Access Compliance Report

Public Rights-of-Way

(Curb Ramps)

Intersection ID: 10031974	Main Street: MONROE_RD	Cross Street: N/A	Location: SW
ADA ID: D545AC5A023F	Ramp Type: Para	Initial Pass/Fail: Fail	Overall Compliance: No
Severity Score: 13.75			
Codes/Mitigation Info/Possible Solution		Field Measurements/Component Compliance

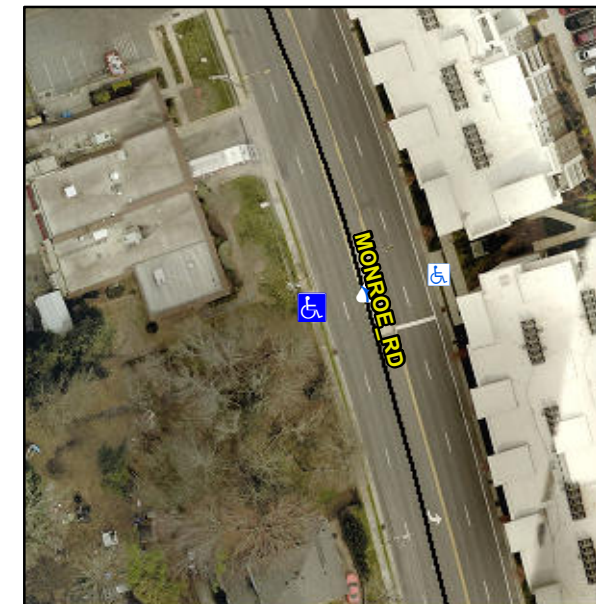
R304.3.2, R304.5.3

Compliance	Description	Data	Compliance	Description	Data
N/A	Ramp Length LT (in)	75.0	N/A	Ramp Length RT (in)	70.0
Yes	Ramp Width LT (in)	67.0	Yes	Ramp Width RT (in)	67.0
No	Ramp Slope LT (%)	9.5	Yes	Ramp Slope RT (%)	6.6
No	Ramp XSlope LT (%)	2.3	Yes	Ramp XSlope RT (%)	0.3
N/A	Landing Length (in)	N/A	N/A	DWS Provided?	N/A
N/A	Landing Width (in)	N/A	N/A	DWS Contrast?	N/A
N/A	Landing Slope (%)	N/A	N/A	DWS Length (in)	N/A
N/A	Landing X Slope (%)	N/A	N/A	DWS Full Width?	N/A
N/A	Landing Curb? (Y/N)	N/A	N/A	DWS Offset (in)	N/A
N/A	Shared Landing?	N/A			
N/A	Gutter Ponding?	N/A	N/A	Gutter Slope (%)	N/A
N/A	Gutter Lip Ht (in)	N/A	N/A	Gutter X Slope (%)	N/A
N/A	Painted X Walk1?	No	N/A	Painted X Walk2?	N/A
	X Walk 1 Direction	To NE		X Walk 2 Direction	N/A
N/A	X Walk 1 Width (in)	N/A	N/A	X Walk 2 Width (in)	N/A
	X Walk 1 Slope (%)	4.6		X Walk 2 Slope (%)	N/A
	X Walk 1 X Slope (%)	0.8		X Walk 2 X Slope (%)	N/A
N/A	Ramp inside XWalk1?	N/A	N/A	Ramp inside XWalk2?	N/A

Remove & Replace Entire Ramp.
